# Memorandum

To: Planning Commission  
From: Elizabeth J Corwin, PE, AICP; Planning Director  
Date: May 7, 2026  
Re: SPR 26-02  
Applicant/Owner: J&J of Highland  
958 N Milford  
PIN 11-22-176-010

SPR 26-02  
J&J Of Highland/Highland Treatment  
958 N Milford  
pin 11-22-176-010

**SITE PLAN**

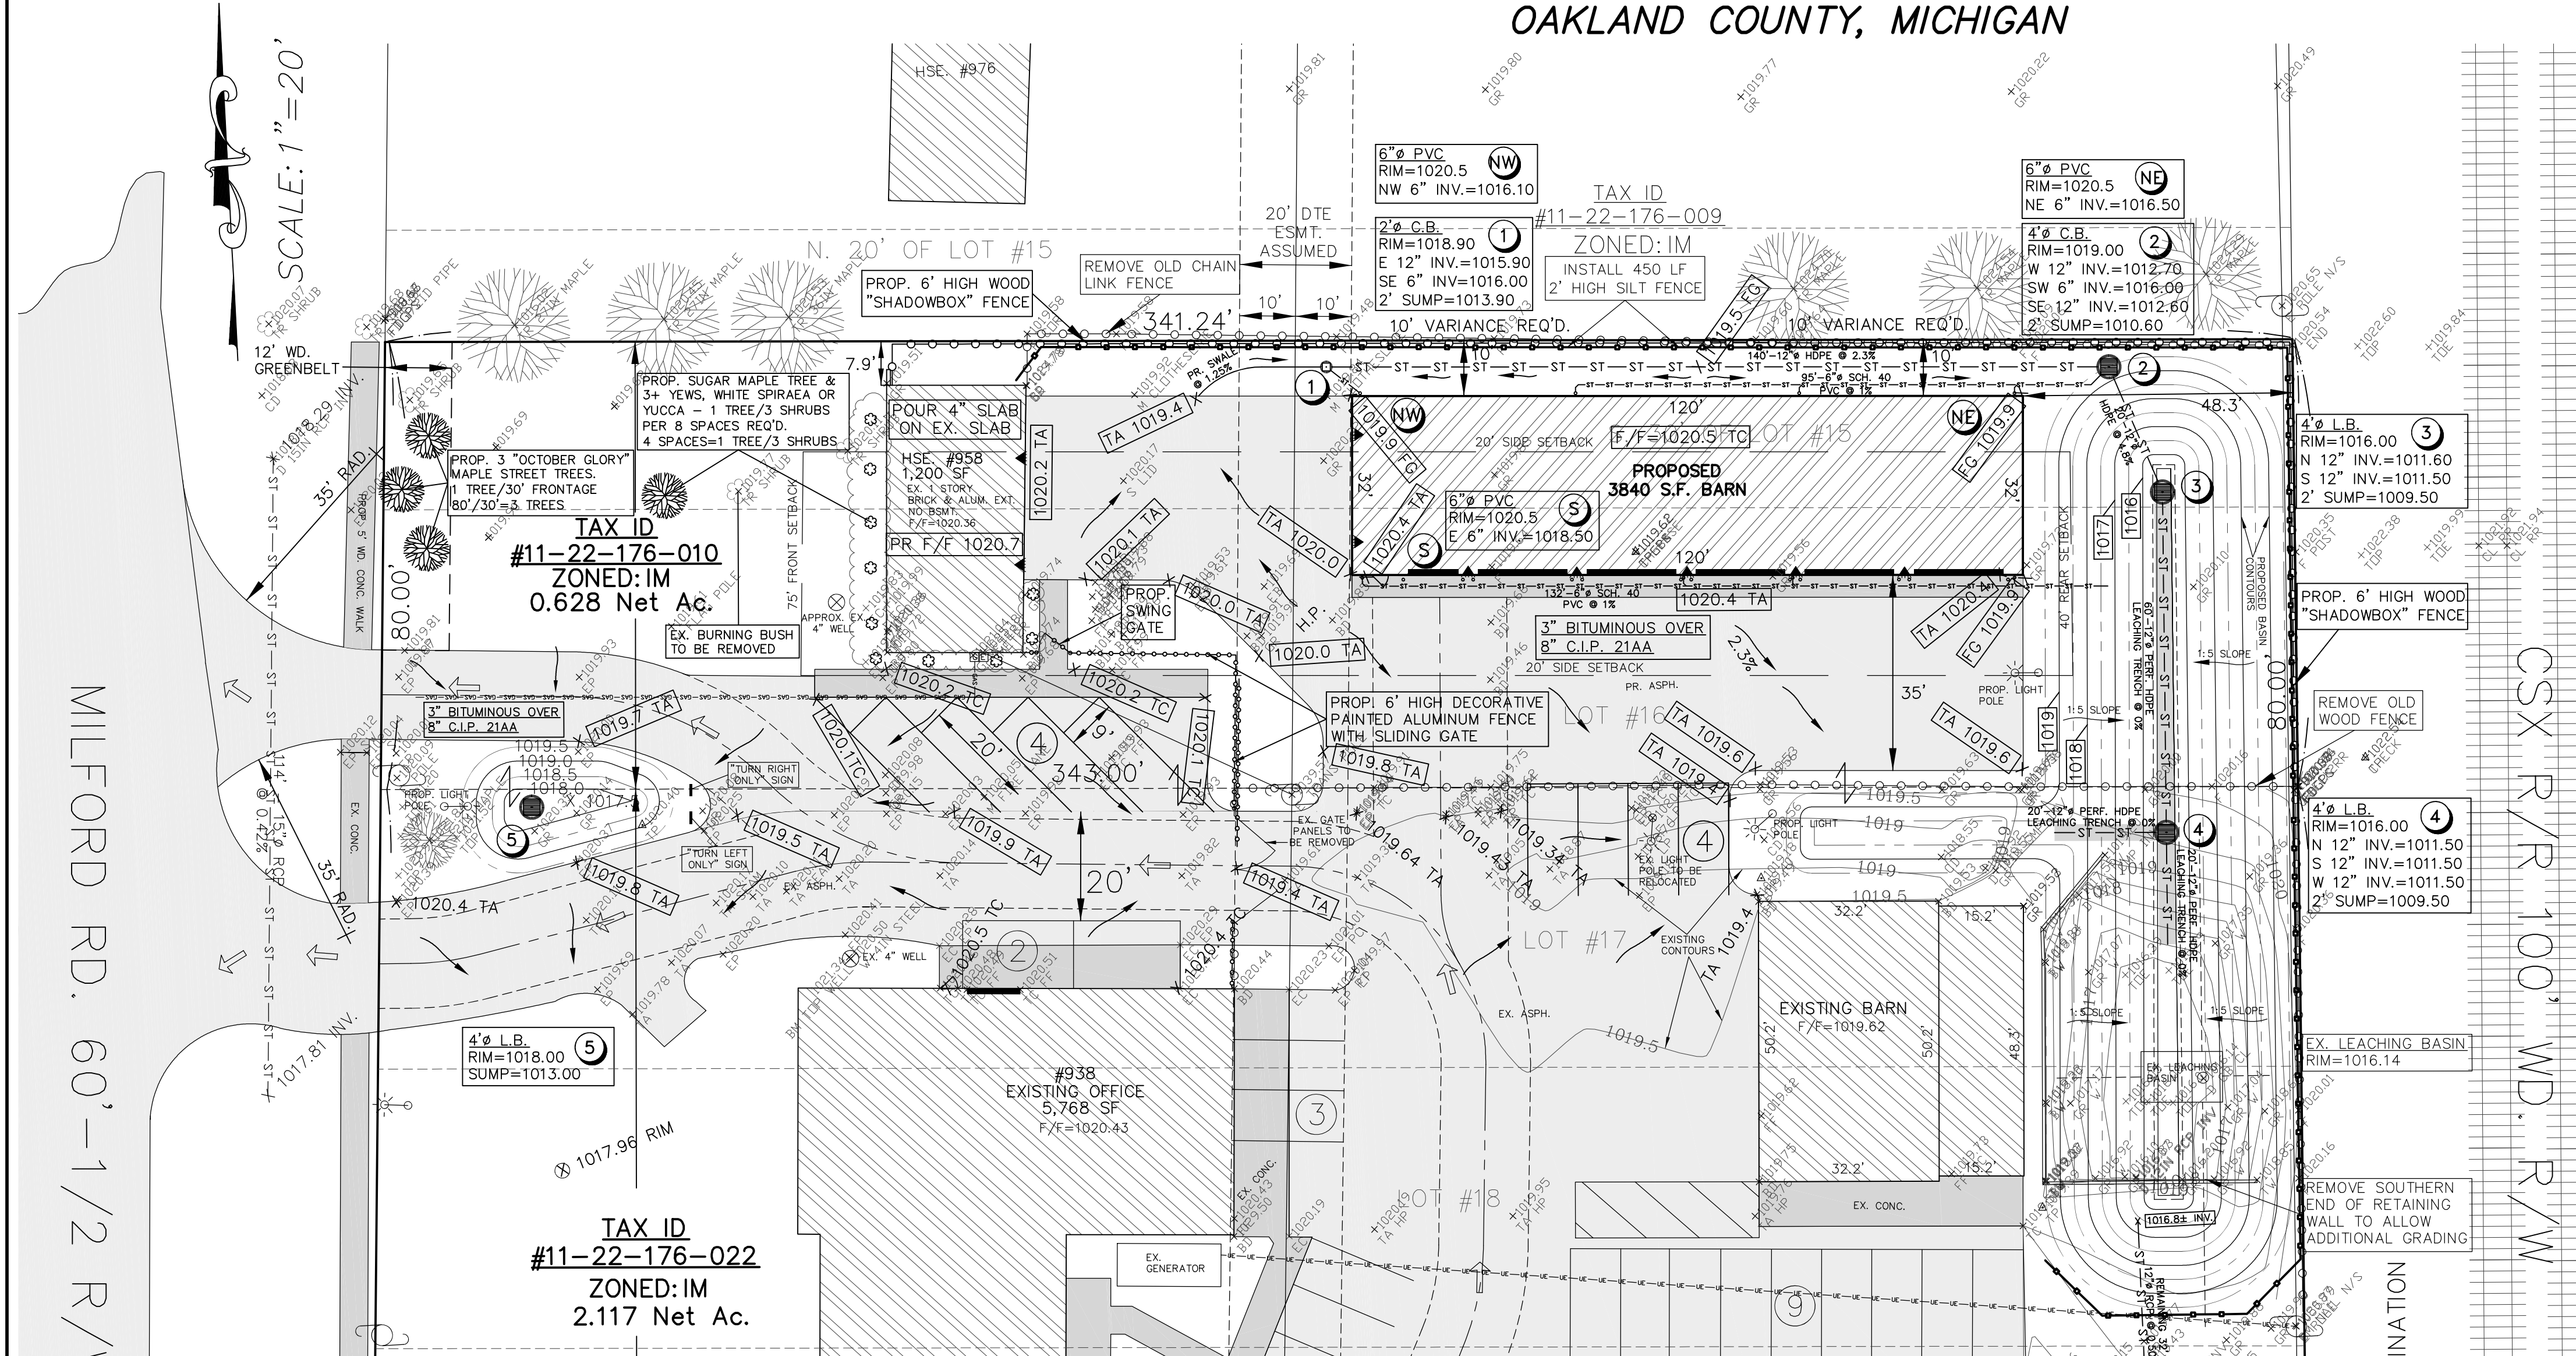
As expected, BF Thompson has presented a thoroughly documented and well considered site design. There is not much to critique. The plan maintains the one-way traffic flow around the site, converting the residential driveway to a one way exit northbound. The plan will include removal of the illicit parking spaces in the Milford Road right-of-way and extension of the existing sidewalk to the new north property line of the combined parcels. Adequate parking is provided, particularly given that the proposed pole building will serve as indoor garage space for company vehicles and equipment.

The plan is to be presented to the Zoning Board of Appeals on May 6 for a variance request of 10 feet from the required sideyard setback on the north property line. Mr. Zeolla will be able to report on their decision at your meeting.

**PROJECT:** J&J OF HIGHLAND  
**SITE INFO:** STORM DRAINAGE PLAN  
**SHEET TITLE:** STORM DRAINAGE PLAN  
**DATE:** 4/10/26  
**Drawn By:** NDT  
**Chkd. By:** BFT  
**Scale:** 1"=20'  
**BFT Job:** #23-4436  
**Sh. 4 of 9**

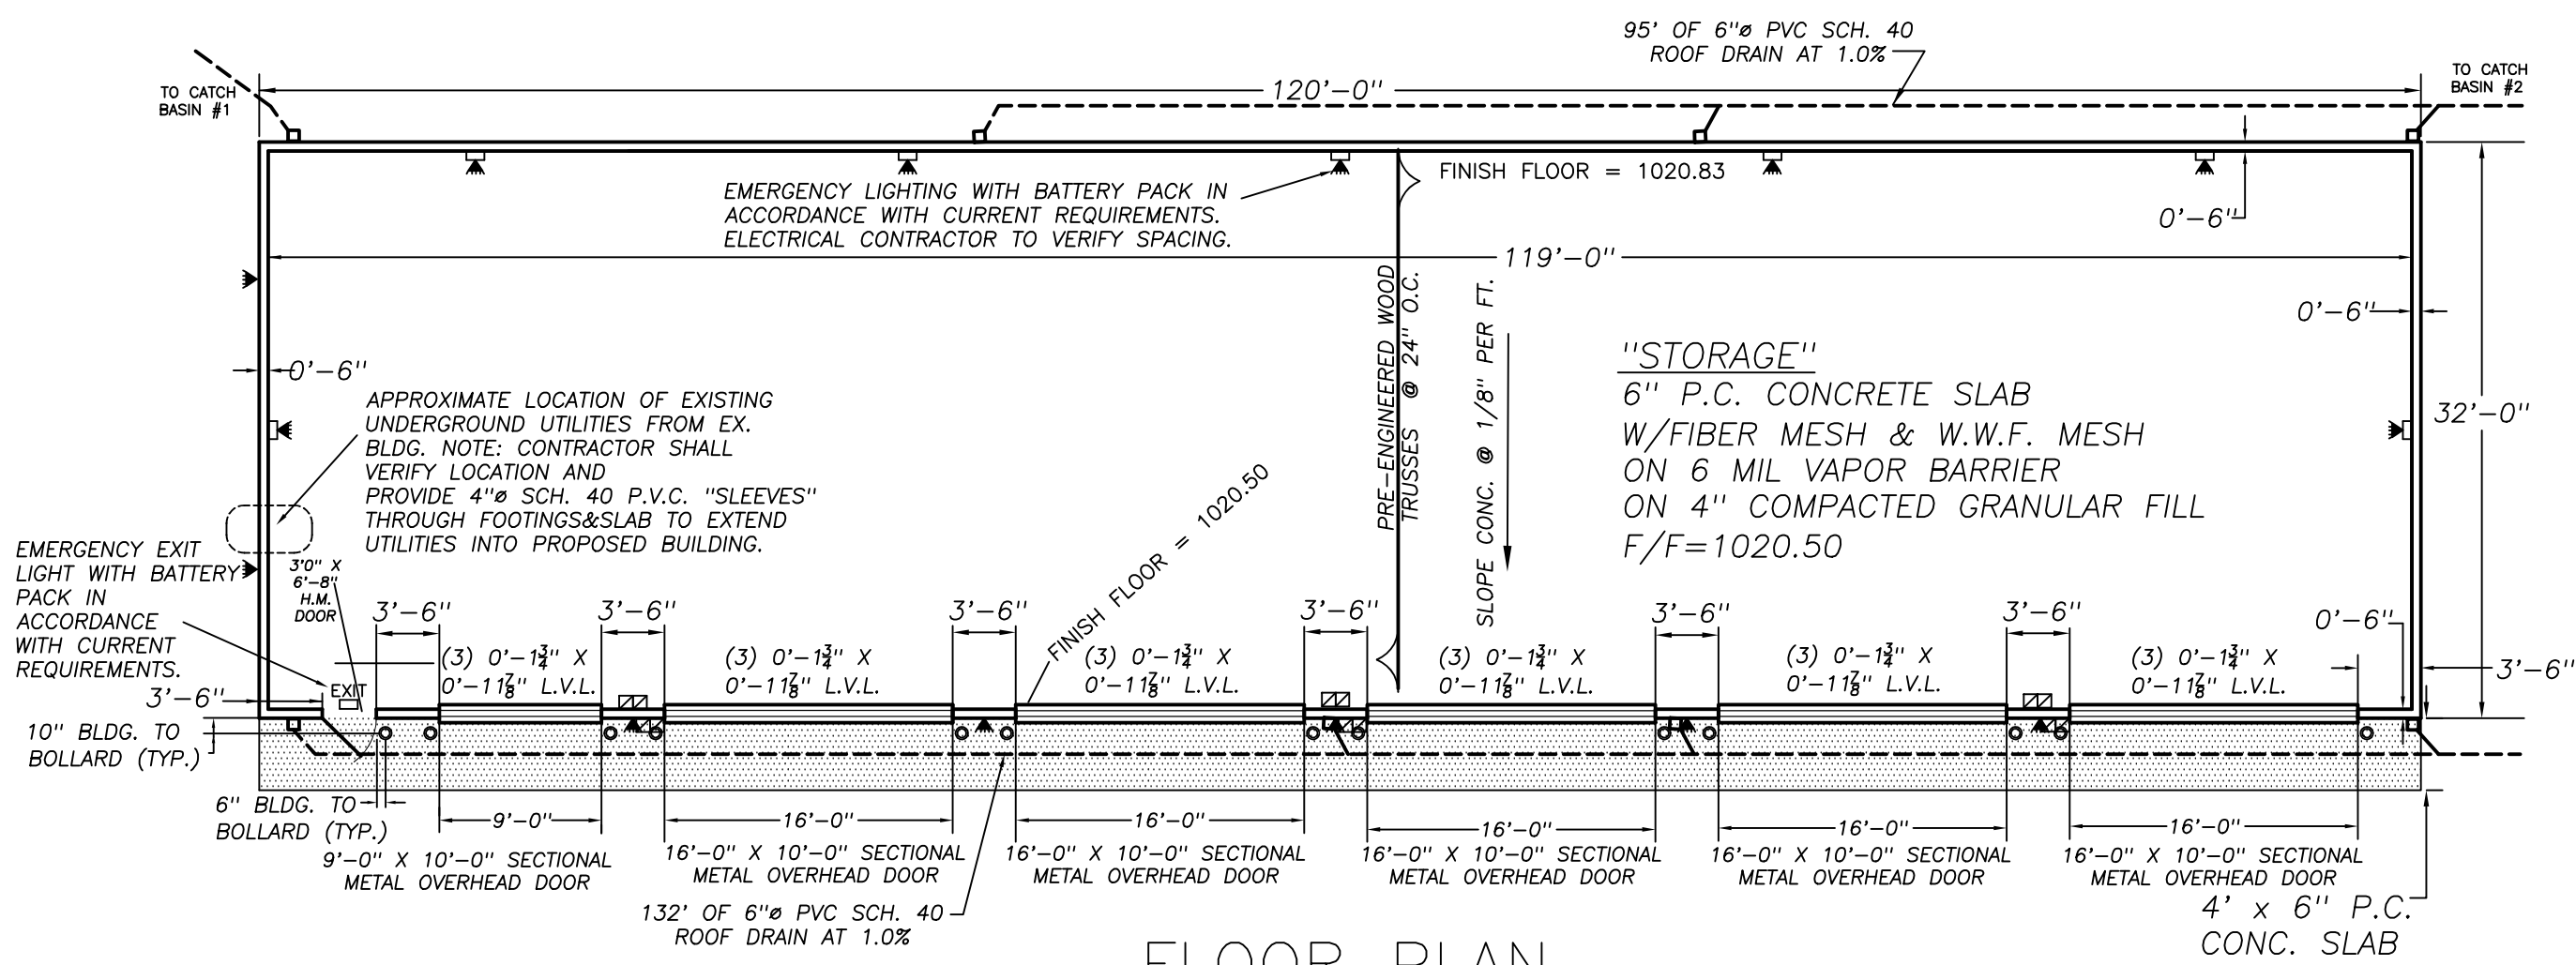
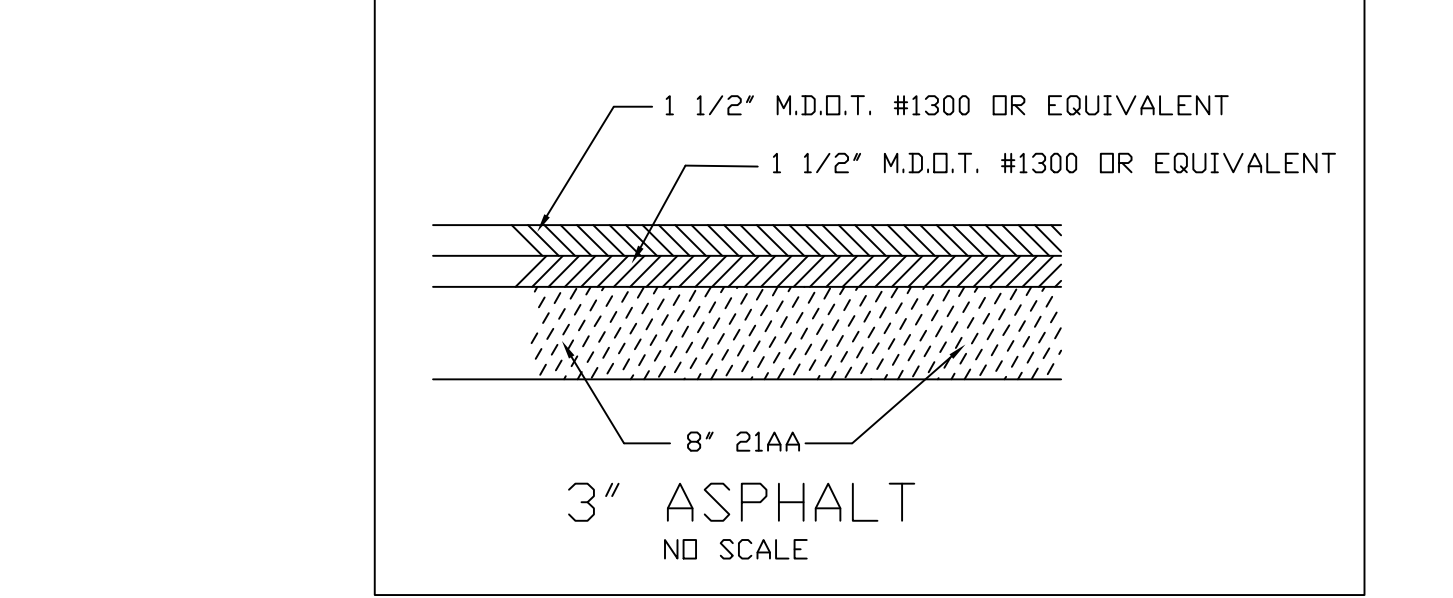
The designer has extended the drainage system using the past design philosophy which has worked well on the site for 30 years. The new buildings will not be staffed, so the existing septic system will be abandoned per Oakland County Health Department standards. It is my understanding that the existing well will be converted to landscape irrigation only.

The Fire Marshal has no concerns with the proposal. While I do not have the Township Engineer review at this moment, I have reviewed the drainage calculations and foresee no issues with approval. Hubbell, Roth and Clark will provide a review before construction.
